Drawing Title: SITE PLAN

PROJECT: FOCO DE CHÃO — Foco de Chao — 15290 Dallas Pkwy, Addison, TX 75001

Foco de Chao 4800 BELT LINE FIRE SERVICE 8/27/01

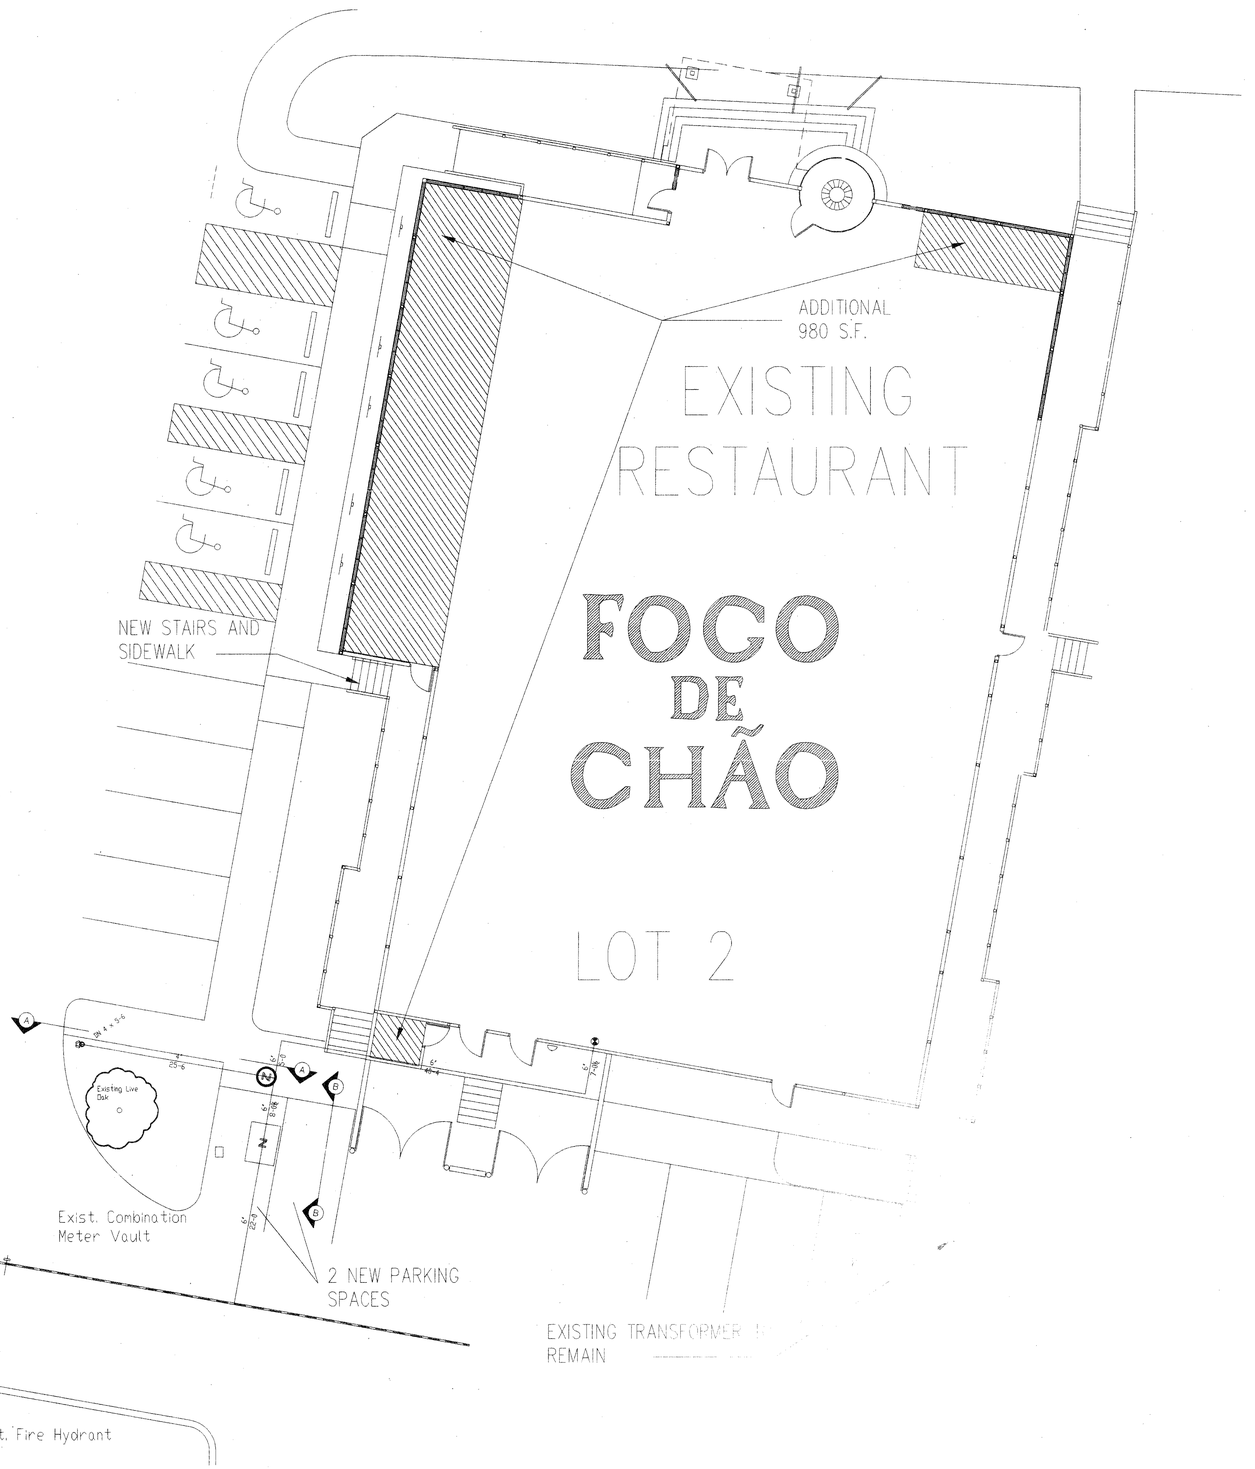
1) USC-FCCHR Approved DCDA required (Fire service)
2) All meters to have remote (touch pad) registerreaders.
3) DCVA required on Domestic service.
BEW 8/27/01
